Southeast Market Pipelines Project

Final Environmental Impact Statement

Docket Nos. CP14-554-000, CP15-16-000, and CP15-17-000
FERC/EIS-0262F

APPENDIX O	COMMENTS ON THE DRAFT ENVIRONMENTAL IMPACT STATEMENT AND RESPONSES
APPENDIX P	SUBJECT INDEX

Fig 1. Graphic of the entirety of information on impacts (lines and circles) as well as mitigation bank coverage (green polygons) listed in the draft DEIS. This information is wildly insufficient. It appears that much of the impact is not being mitigated.

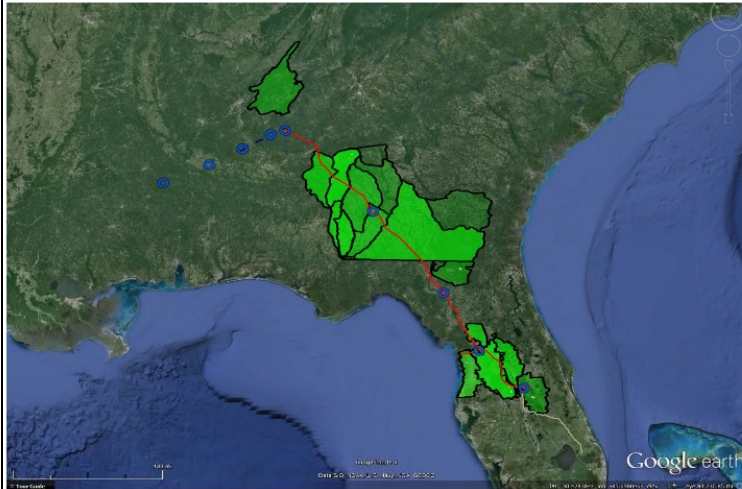
The Figure above represents the information available on the possibility of mitigation for the project by the DEIS. Lines are estimates from a crude graphic of the Southeast Market Project, rather than a precise display, because there is no other geographic information available on wetland impacts, even in the 70 page appendix.

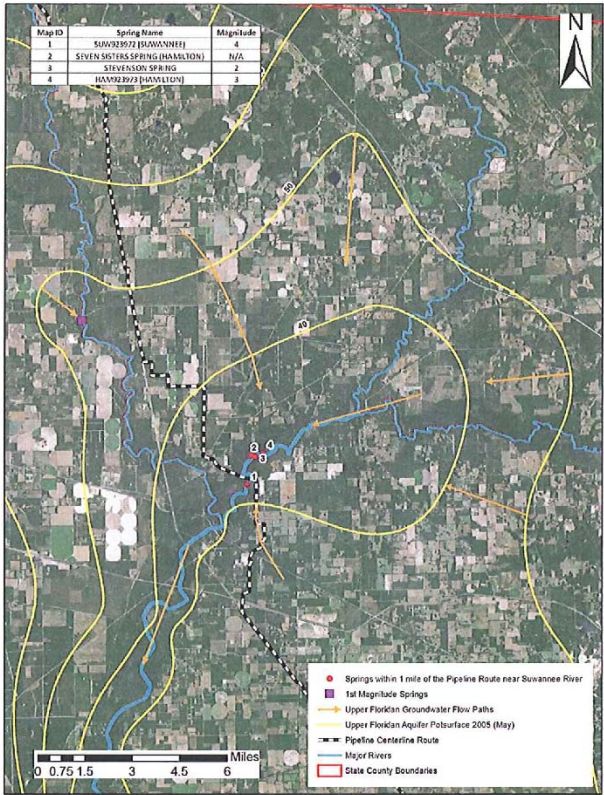
Figures 1 and 2 show the location of the Suwannee and Santa Fe River crossings, respectively, locations of springs within several miles of the river crossings, and the potentiometric surface contours indicating the

Figure 3. Close-Up View of the Location of the Proposed HDD Crossing of the Suwannee River. The Figure Shows All of the Springs within a One Mile Radius of the Crossing.

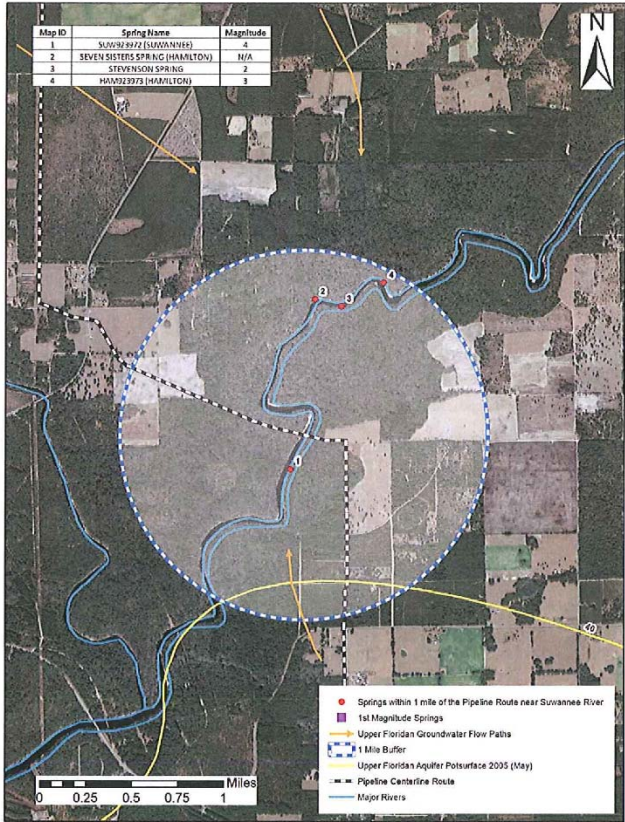
Figure 3 is a close-up view of the proposed crossing of the Suwannee River. The figure shows all of the springs within a one mile radius of the crossing. The nearest spring is designated Suw923972, is 4th magnitude, and is approximately 1,096 feet down river and down gradient in the flow system of the crossing. Because this spring is down gradient of the crossing and relatively near it, the potential exists for it to be affected by drilling fluid during HDD operations.

There are three springs upriver and up gradient in the flow system of the crossing. They are Seven Sisters Spring of unknown magnitude and Stevenson Springs, 2nd magnitude, at distances of approximately $\frac{3}{4}$ of a mile up gradient in the flow system of the crossing and HAM923973, 3rd magnitude, at a distance of approximately one mile up gradient in the flow system from the crossing. Because these springs are at significant distances up gradient of the crossing, it is unlikely that if drilling fluid intersects an active conduit, it will travel up gradient and against the flow of water in the aquifer to these springs.
